# St. Peters Anglican College, Community Hub, Sports & Recreation Centre Project

Southern Regional Planning Panel  
Request for Information

Report prepared by Colliers International Project Leaders  
14 December 2023

**Application No.** DA0078/23

Figure 01: APZ for P10 Sports and Recreation Centre

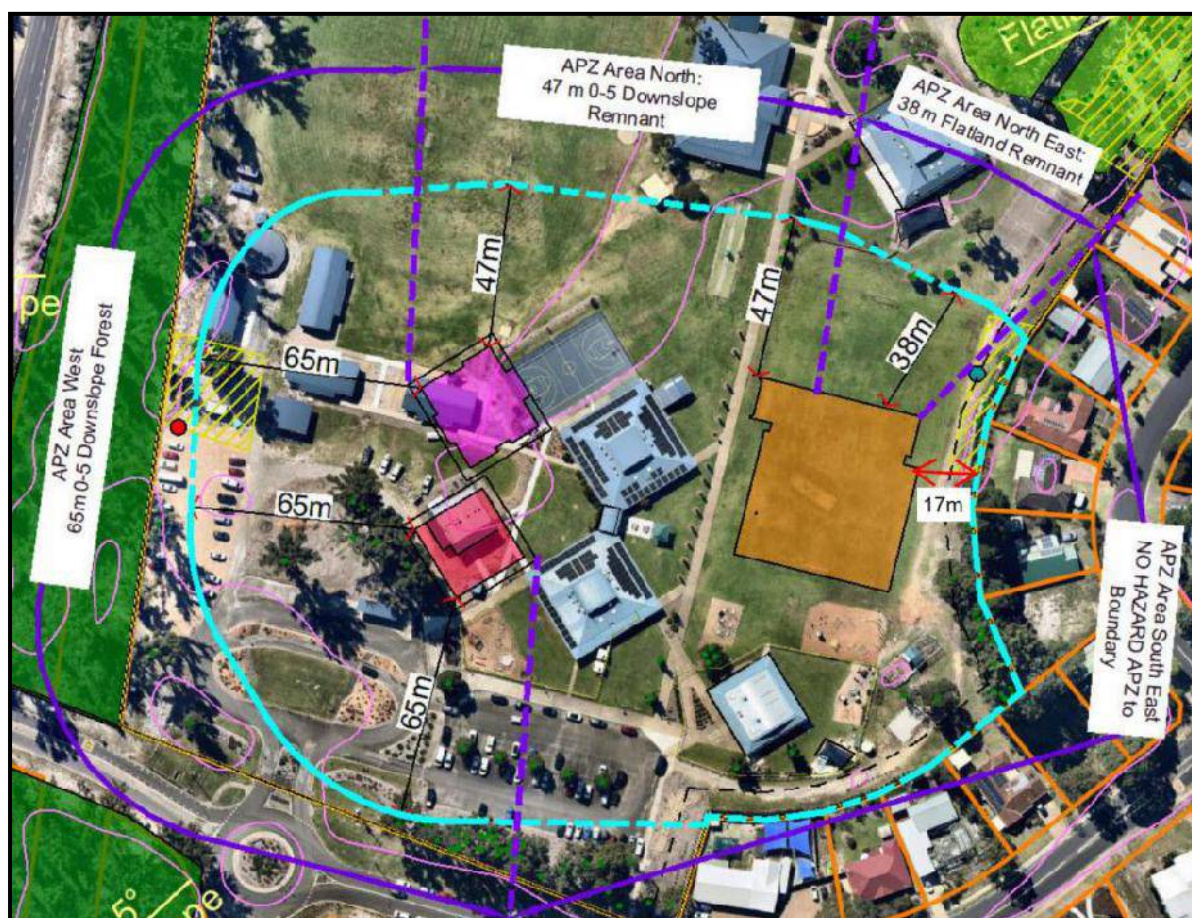
***Revised NSW Rural Fire Service, 'General Terms of Approval' confirming APZ requirements for building P10 are wholly located within the site (in particular, clarification that the requirements for the 38m APZ to the east of the building P10 should be amended to require the APZ to the eastern boundary of the site).***

An amended 'Bushfire Assessment Letter' has been provided at **Appendix A** to clarify the APZ surrounding the Sports and Recreation Centre (P10) - The letter clarifies the implementation of the APZ to the east of the Sports and Recreation Centre (P10) can be less than 38m because the assessment of the classified vegetation to the east is managed land, and this is not classified as a hazard. Therefore, it can be only 17m as depicted below.

*Figure 02: Revised Front of Campus Carpark and Bus Loop Design*

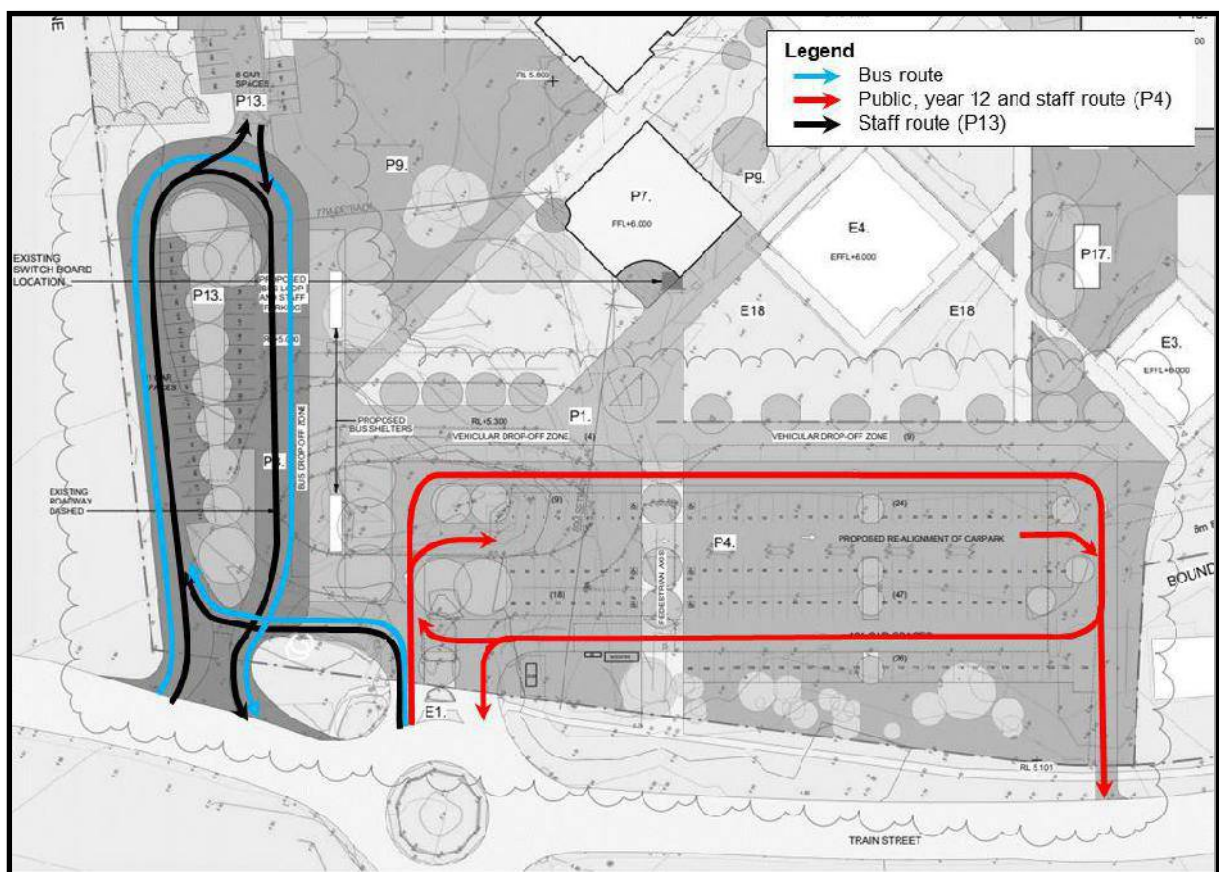
#### **Consideration of the safety and manoeuvrability aspects for vehicles entering the staff car park (P4) from the east, using the roundabout, and clarification of traffic control arrangements for this intersection.**

- The revised car park and bus loop design works hard to separate out bus and car movements as much as possible and creates a clear designation of travel path through P4 including through maintaining one-way circulation to minimise conflict of circulating vehicles.

- It is proposed to retain the existing vehicle access point in its current form with primary access via Train Street for the eastern on-site car park (P4), as well as the public drop off and pick up zone.

- An additional egress from P4 (left turn out) at the eastern edge of the car park has been provided to reduce the quantum of vehicles using the Train Street roundabout. The proposed location will result in no loss of on-street parking.

- Swept path analysis contained in the traffic report indicates the site access and car park layout has been designed to accommodate relevant design vehicles, including B99th percentile vehicles (cars, vans utes), minivan and fire appliance.

Figure 05: Acoustic Consultant mark-up showing re location and re-orientation of mechanical plant to P10

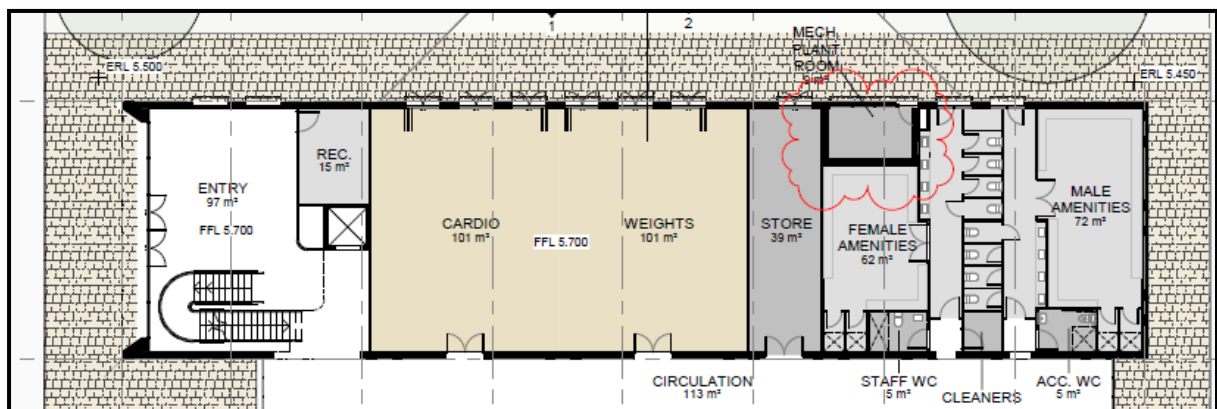
**Details of the location of mechanical plant for P10 and justification for the proposed acoustic wall.**

- Options and alternative mitigation measures available to negate the need for the acoustic wall; and***
- Any amendments required to the acoustic report and other relevant plans in response to any changes or updated provisions relating to the need for the acoustic wall and ongoing monitoring of noise from mechanical plant.***

The applicant has worked with the design team to re-locate and re-orientate the mechanical plant room on the Sports and Recreation Centre (P10). The mechanical plantroom now opens up to the North (previously

towards the East) and based on acoustic engineering advice, this will comply with the daytime noise criteria of the Noise Policy for Industry.

Furthermore, the plant room has moved to the west of the amenity area increasing the distance from the eastern boundary to over 30 meters, this along with the below removes the need for the acoustic fence.

Due to these changes and noise reduction measures, there is no longer the need for the acoustic fence, and therefore, can be removed from the development application improving the visual amenity and outlook from the Eastern residential boundary.

*Figure 06: Danpalon Sample Comparison between Gloss and Matt finish*

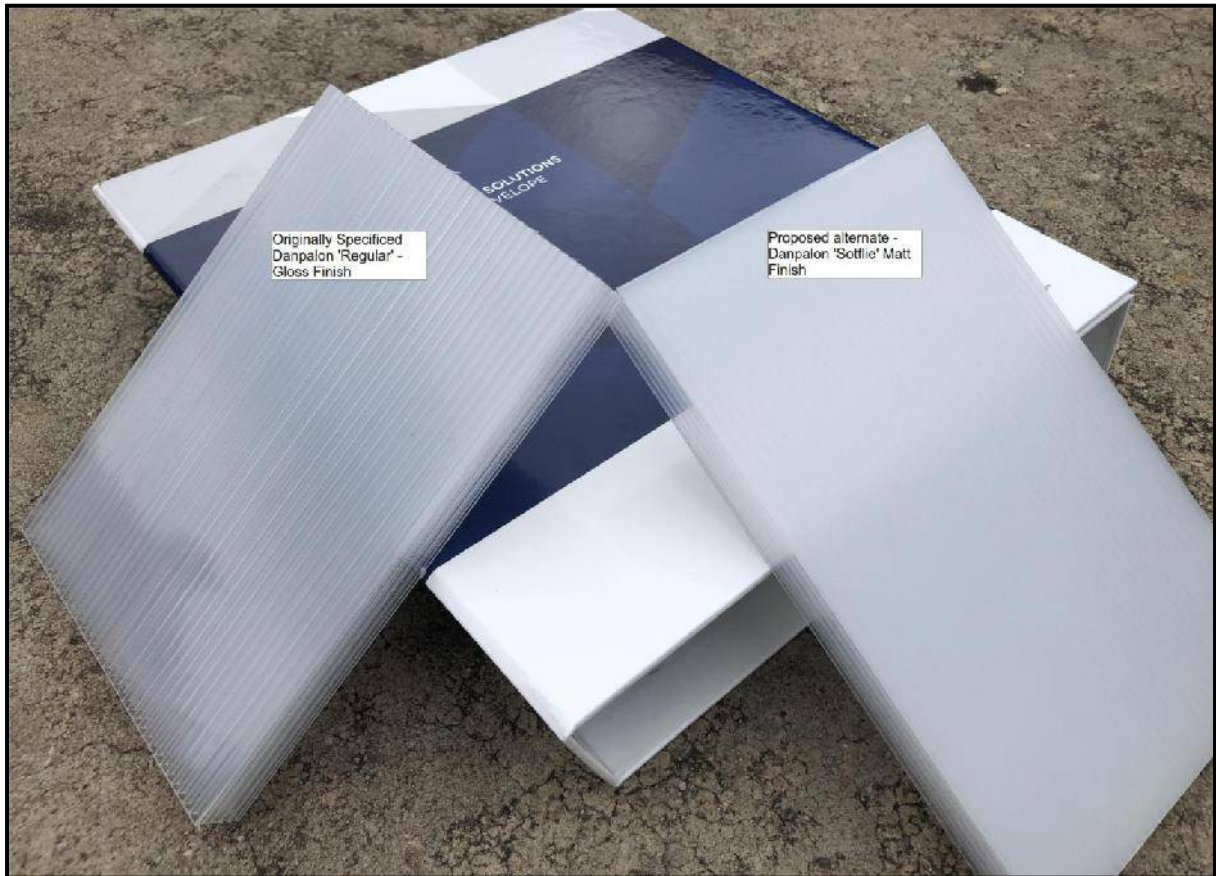
#### **Consideration of the potential glint and glare impacts from proposed building P10 on residential receptors particularly to the east.**

The luminance of the specified 'Regular' Danpalon façade product exposed to sun remains consistent with comfortable human activity visually. However, in the interest of addressing the glare sensitivity concerns of the eastern neighbours, the applicant will propose a lower glare alternative called 'Softlite' within the Danpalon range. The 'Softlite' product is a 'matt' alternative to the standard Danpalon version further reducing glare from the façade. All other properties of the Danpalon facade remain the same. See **Appendix D** with a copy of the glare data comparison between 'Regular' and 'Softlite' Danpalon.

FIGURE 2 CLOSE-UP OF APZ AND SEGMENTS ACROSS THE SITE

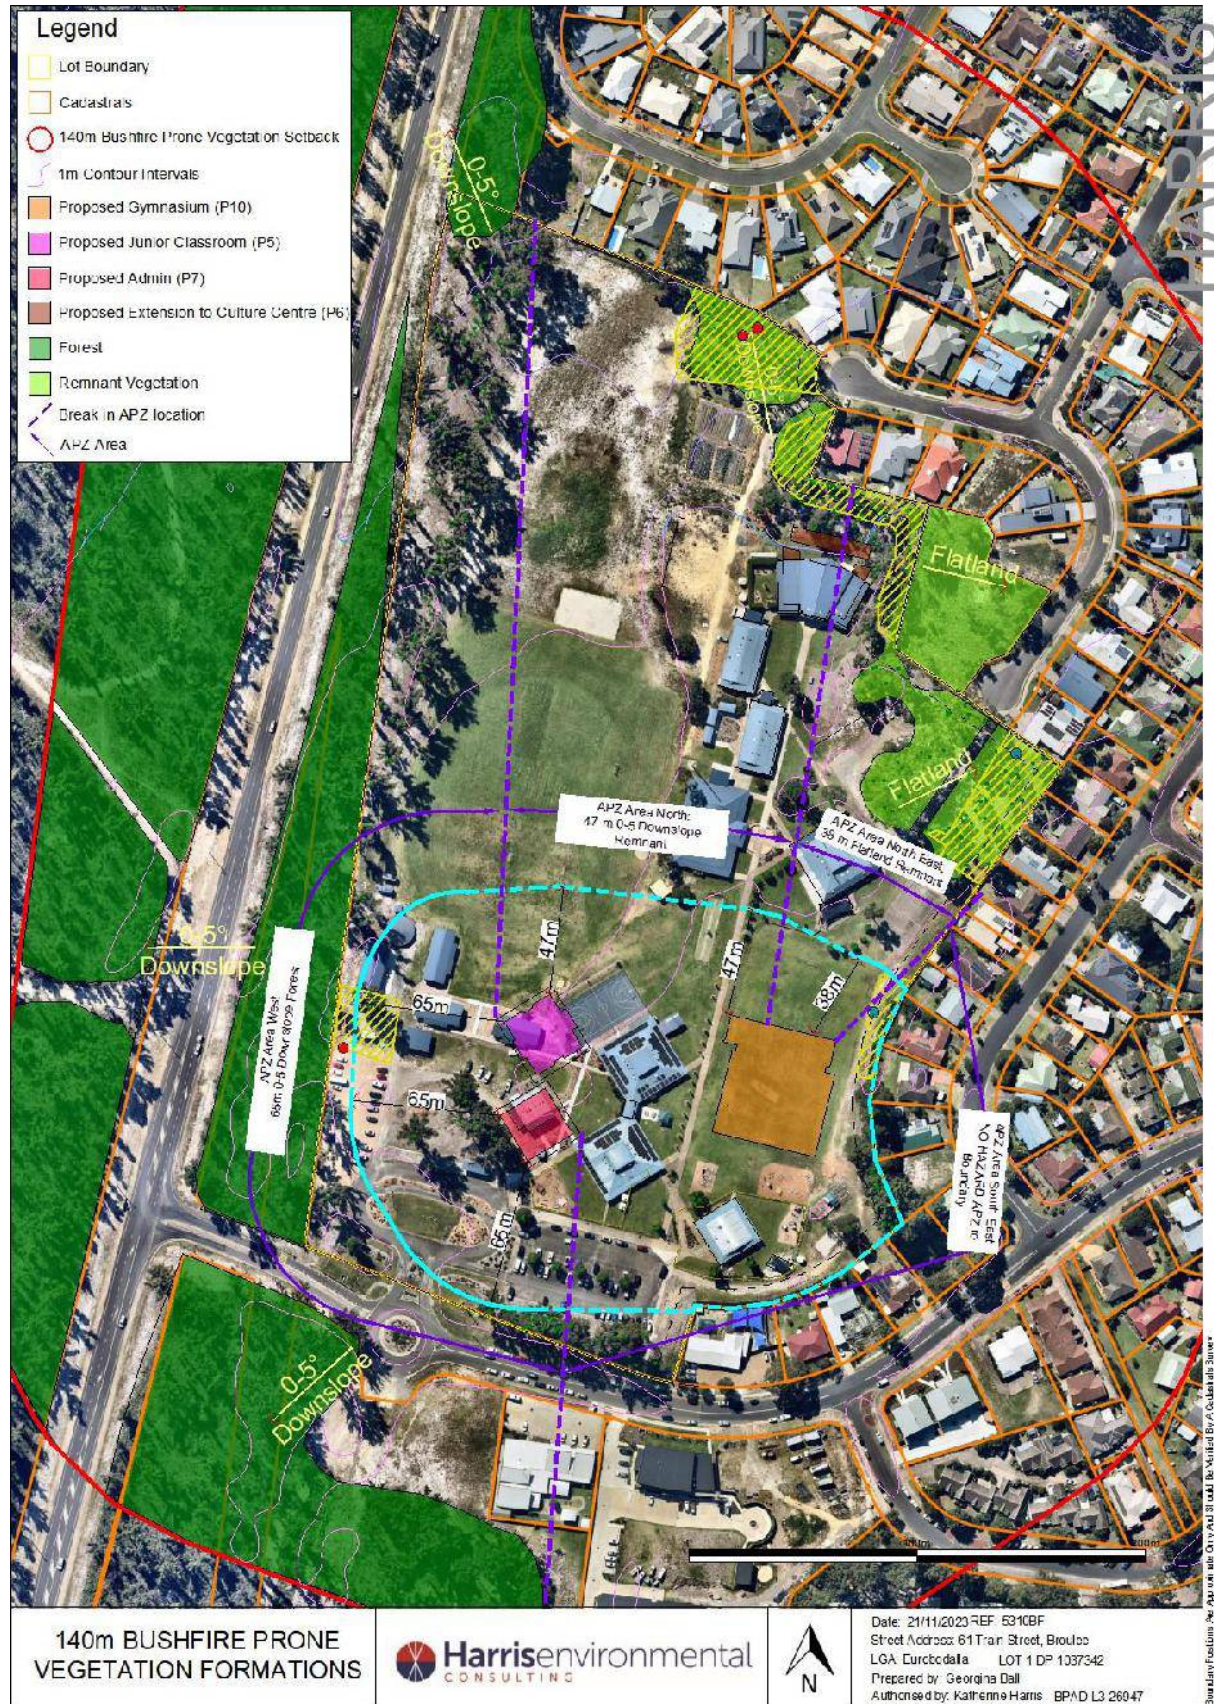
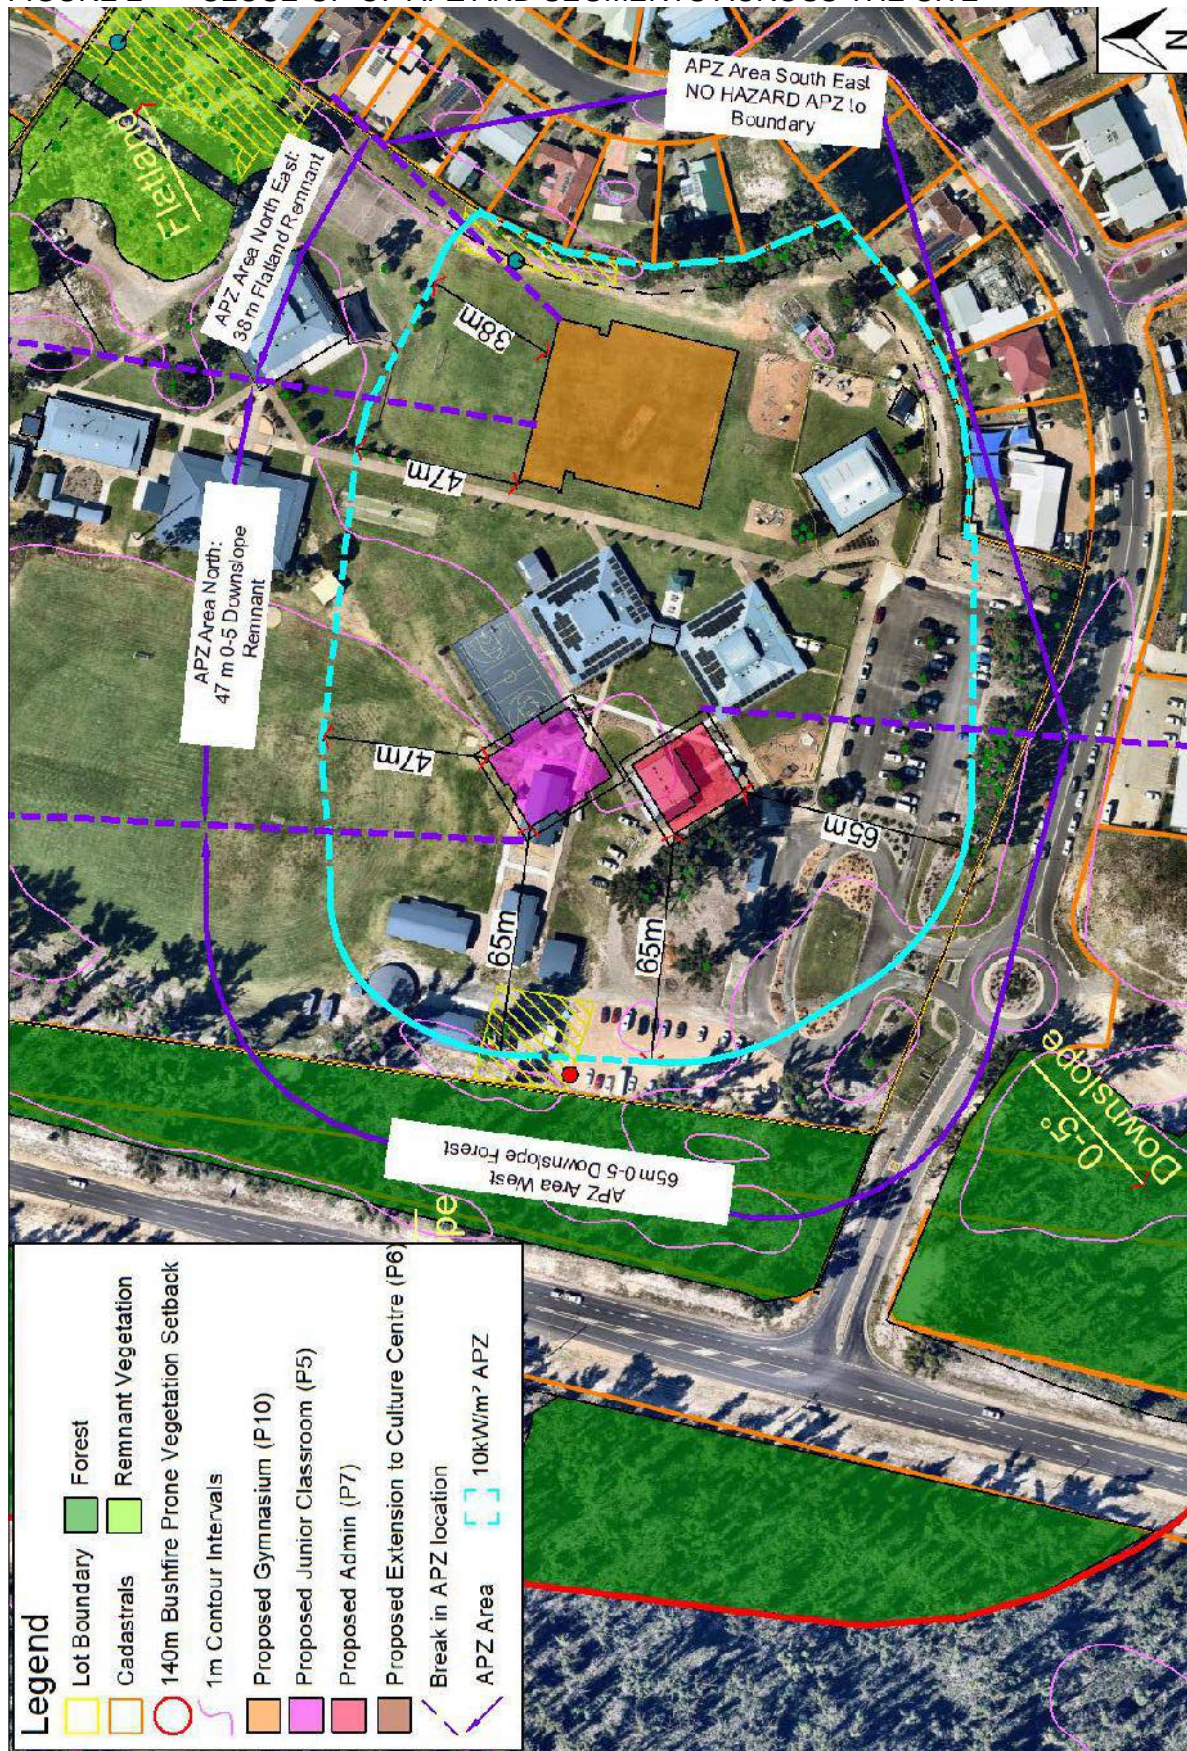
1. Revised NSW Rural Fire Service, 'General Terms of Approval' confirming APZ requirements for building P10 are wholly located within the site (in particular, clarification that the requirements for the 38m APZ to the east of building P10 should be amended to require the APZ to the eastern boundary of the site).
7. Consideration of opportunities for additional landscaping to provide a more sympathetic outlook for residents located to the east of building P10 taking into consideration the need to establish the APZ.

All Asset Protection Zones (APZ) comply with the NSW GTAs in that they are provided for the distance *in the direction of the hazard only*.

As shown in Table 1, the assessment of the classified vegetation formations detailed in the Bushfire Hazard Assessment includes managed land to the east of the proposed development. The identified bushfire hazard is located in the north, northeast, south and west, as detailed in Table 1. The bushfire hazard on the north and east is within the subject site; therefore, the APZs are also provided within the subject site in the direction of the bushfire hazard.

Table 2 from the Bushfire Hazard Assessment summarises Table 1 into the remaining vegetated directions and the associated APZs. An APZ is not required for the direction for which the land is managed, only for that in the direction of the hazard. A visual depiction of this APZ is illustrated in Figures 1 and 2, where the APZ directions are segmented in purple. The APZs are consistent with the GTAs provided by the NSW RFS. It should be noted this APZ is not located in land mapped Biodiverse.

**Figure 1.1 – Revised site layout**

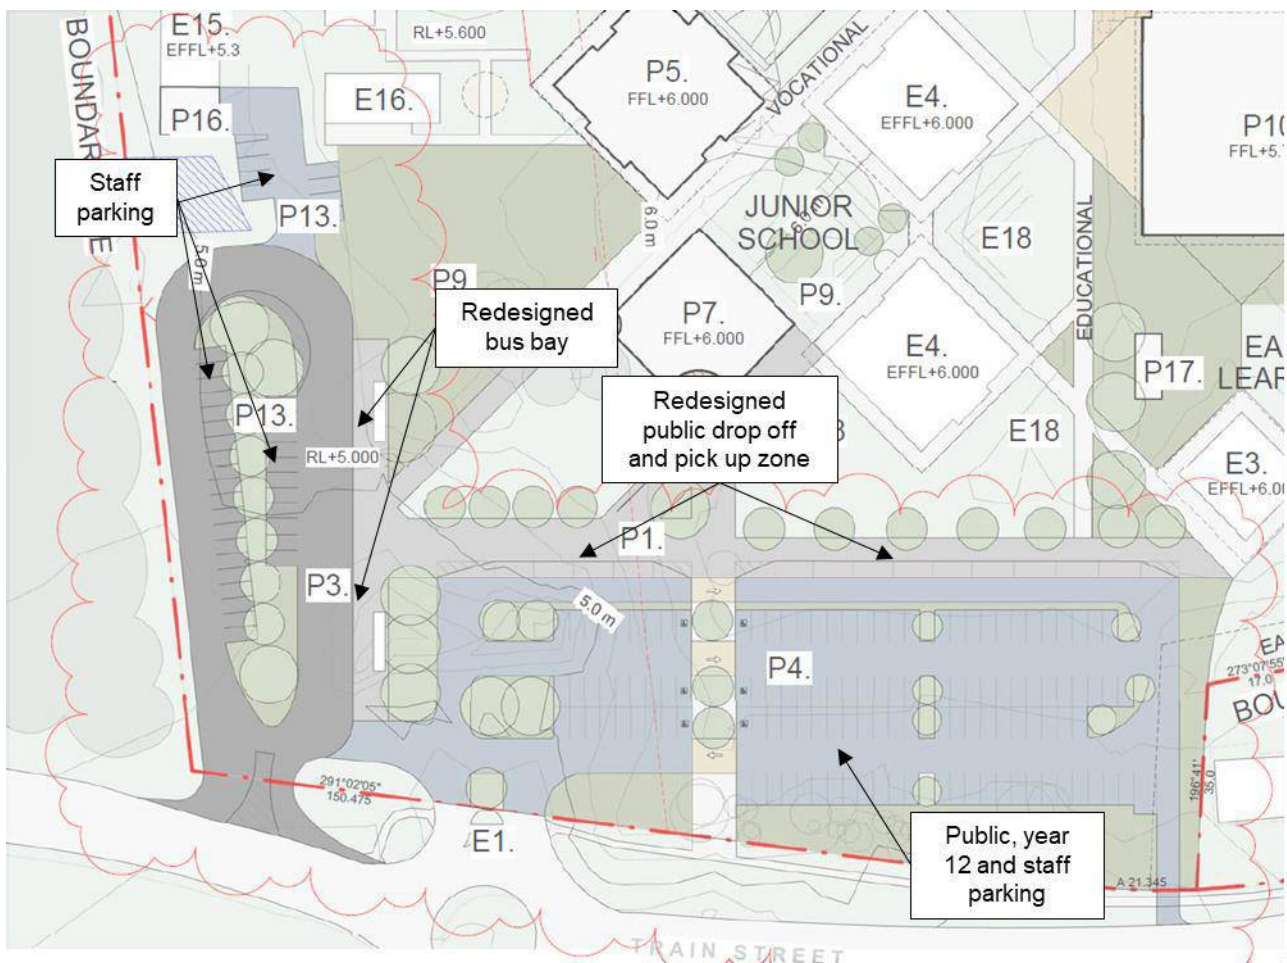
*3. Consideration of the safety and manoeuvrability aspects for vehicles entering the staff car park (P4) from the east, using the roundabout, and clarification of traffic control arrangements for this intersection.*
